# Review of Indian seismic code, IS 1893 (Part 1) : 2002

**Sudhir K Jain**

Fig 1 (a) All floor definition of centre of rigidity (b) Single floor definition of centre of rigidity

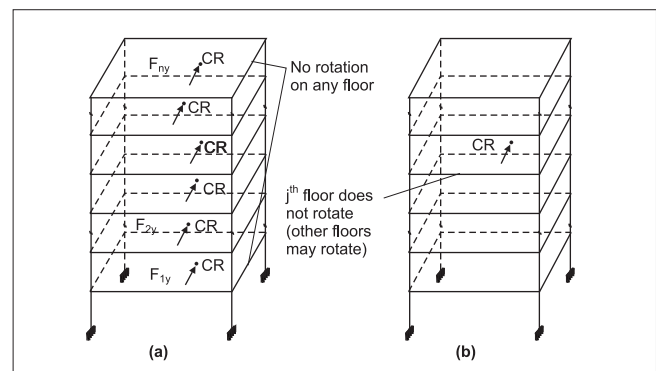
difference is not very substantial. Hence, choice of the definition should be left to the designer and the above definitions should be added in the code.

Fig 3 Suggested treatment of stiff structures with fundamental period less than 0.1 second

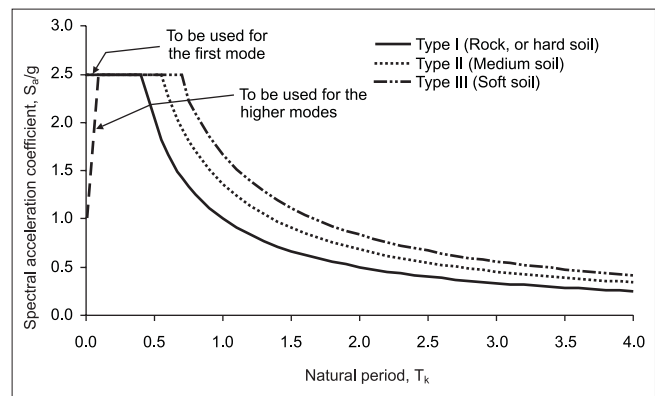
The codes have traditionally followed a different approach for very stiff buildings: they simply disallow the use of rising part of the spectrum curve between  $T=0$  second to  $T=0.1$  second for static analysis, and for first mode of the dynamic analysis. Fig 3 illustrates the suggested provision that takes care of the stiff structures adequately without any ambiguity.

**Fig 4 (a) First equation for design eccentricity (b) Second equation for design eccentricity**

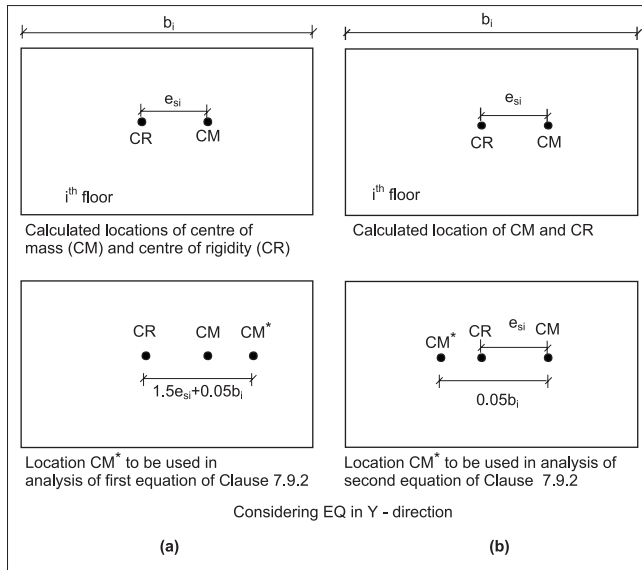
In the first equation, the intention is to add the effect of accidental eccentricity to 1.5 times calculated eccentricity

(Fig 4(a)) and hence, the first equation should be taken to mean having + and - sign for the second term, whichever is critical:

In second equation, it is expected that there is accidental eccentricity in the opposite sense, that is, it tends to oppose the computed eccentricity. Hence, factor 1.5 is not applied to the computed eccentricity, Fig 4(b). Again, this equation also should have + and - sign for second term, and whichever is critical should be used.

$$e_{di} = 1.5e_{si} \pm 0.05b_i$$

$$e_{di} = e_{si} \pm 0.05b_i$$

Fig 5 Corrections in Fig 3 A of IS 1893 (part 1) : 2002<sup>2</sup>

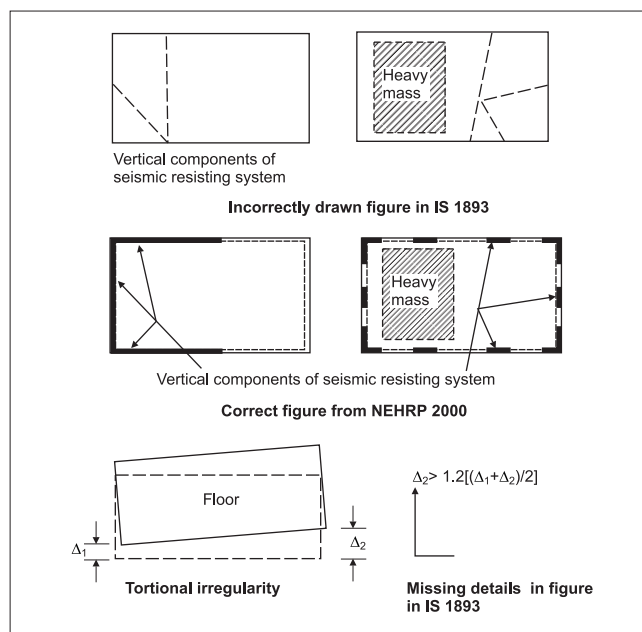
In this edition of the code, irregular configuration of buildings has been explicitly defined in Tables 4 and 5; these tables have been adapted from similar Tables in NEHRP Code. Figs 3 and 4 of the code illustrate some of these irregularities. These figures are taken from NEHRP and from Jain<sup>8</sup>. Unfortunately, there are errors in these figures and these need to be corrected. Fig 5 shows the incorrect figures of the code and the correct figures from the original sources.

Fig 6 Corrections in Fig 3 C of IS 1893 (part 1) : 2002<sup>2</sup>

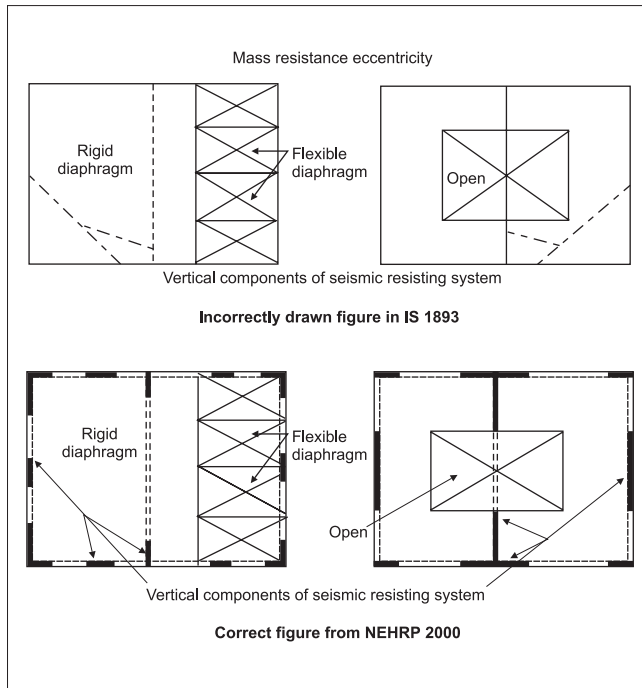
In Fig 3B of the code, irregularity due to reentrant corner is defined as  $A/L > 0.15-0.20$ , while in Table 4, it is defined as 15 percent. It will be best if the figure also shows only  $A/L > 0.15$ .
